Dealer Service Instructions for:

# **Safety Recall ZA3 / NHTSA 22V-835**

## **6.7L Ram Heavy Duty Truck**

### **Transmission Dipstick**

**Figure 3 – Locking Dipstick Installed**

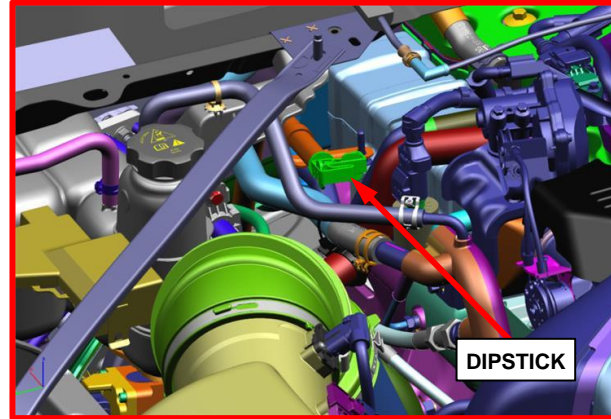
5. Lock the dipstick by rotating the lever 90 degrees to the tube centerline. The locking lever should sit in the orientation shown when fully seated and locked (Figure 3).
6. Close the hood.

**Figure 5 – 44" Dipstick Markings**

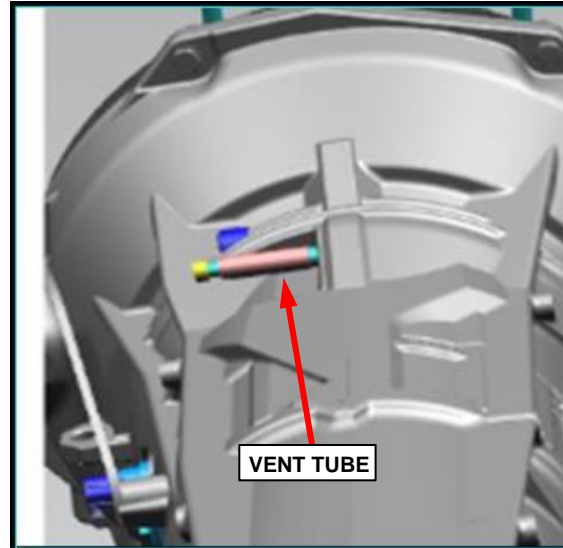
**NOTE: If equipped with a 15" dipstick, it is marked with a warning against using it to check fluid level. The 44" stick markings are shown for comparison (Figures 4 and 5).**

**Figure 7 – New Vent Tube**

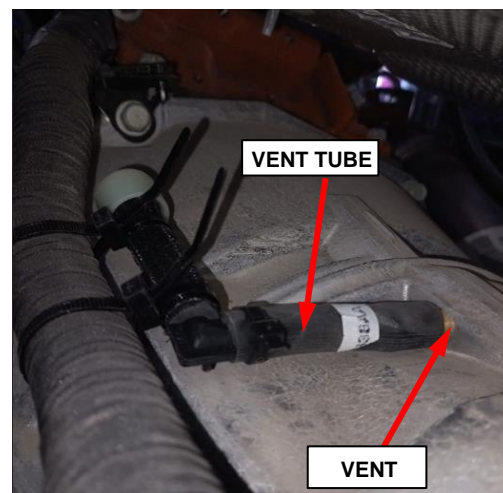
3. Install the new transmission vent tube to the transmission vent (Figure 7).
